# ADA Curb Ramp New Construction Inspection Form (Parallel)

Nw. Glencoe rd

24952.54

Nw. Pacific st.

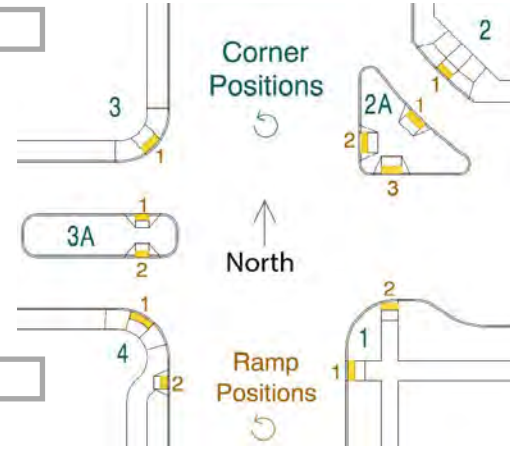
IITD, large comm. box in RR2
